SUNDRY NOTICES AND REPORTS ON WELLS
Do not use this form for proposals to drill or to re-enter an abandoned well. Use form 3160-3 (APD) for such proposals.

8. Well Name and No.
WIGEON 23 FED COM 4H

9. API Well No.
30-015-43156-00-X1

Cimarex respectfully request approval to change the BHL there by changing the directional plan. No additional surface disturbance is required.

Cimarex
 Wigeon 23
 Federal Com 4H
 - PBHL [330'
 FNL, 330' FEL]

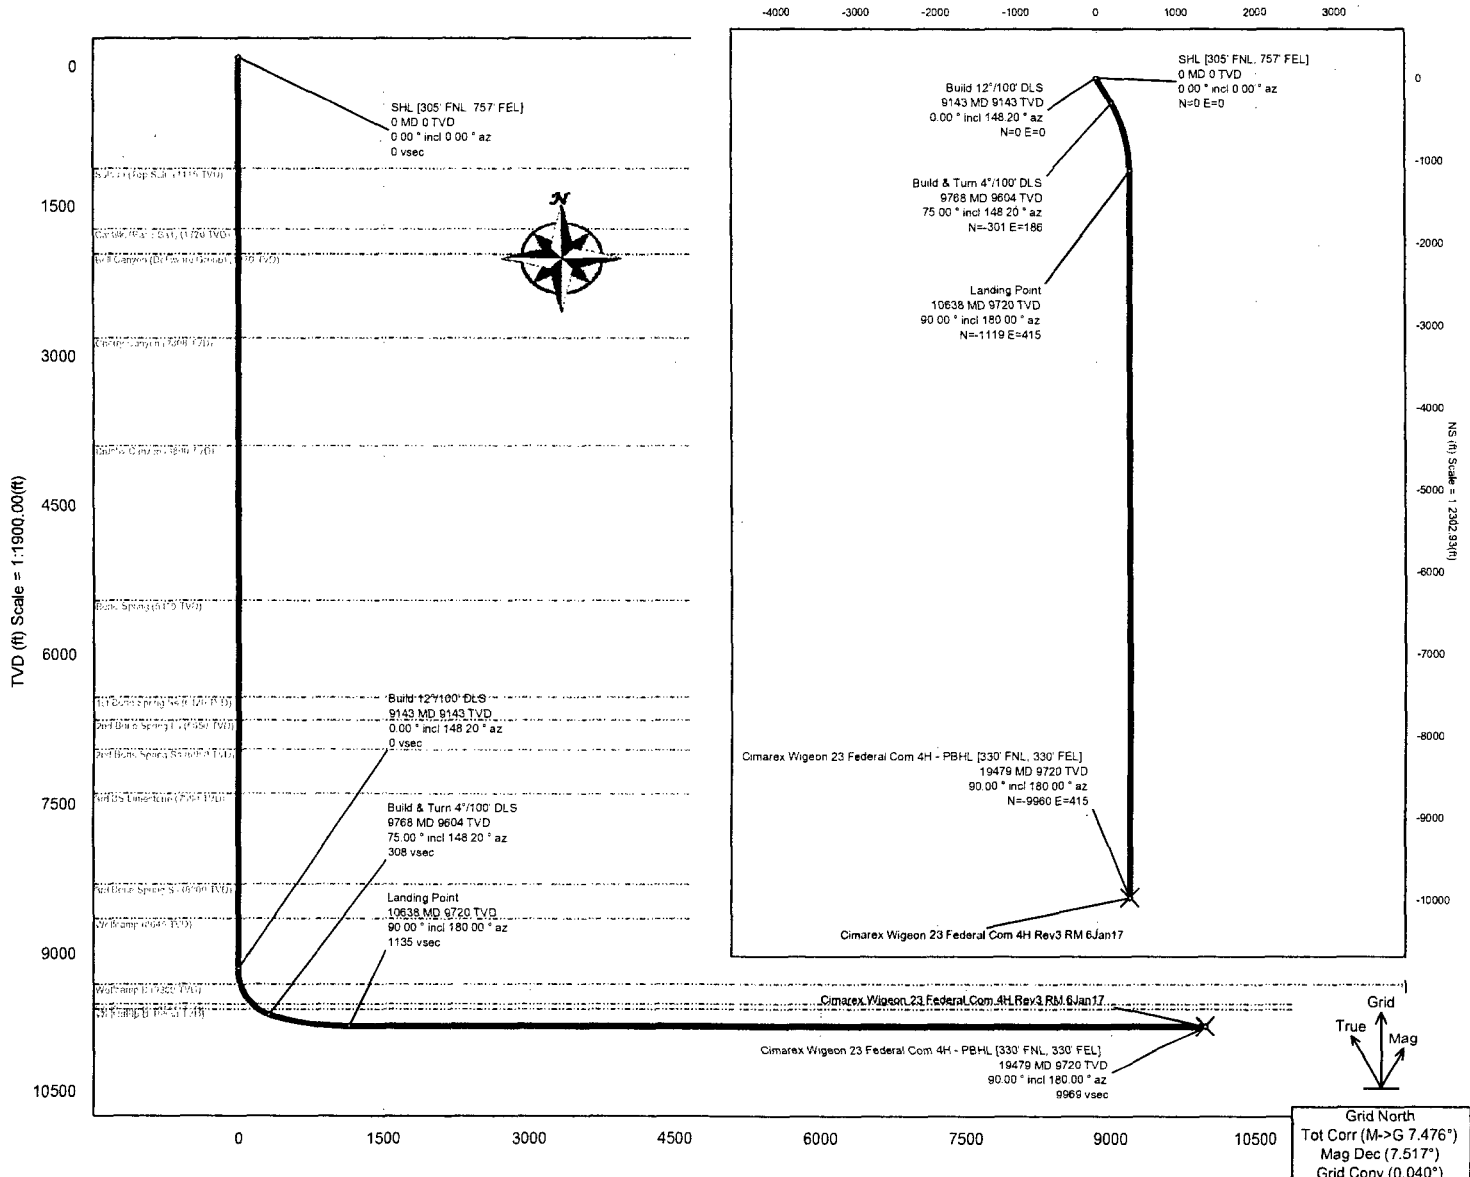
Approved:
BHL: 330 FSL & 660 FEL Sec. 26-25S-26E
Proposed
BHL: 330 FSL & 330 FEL Sec. 26-25S-26E
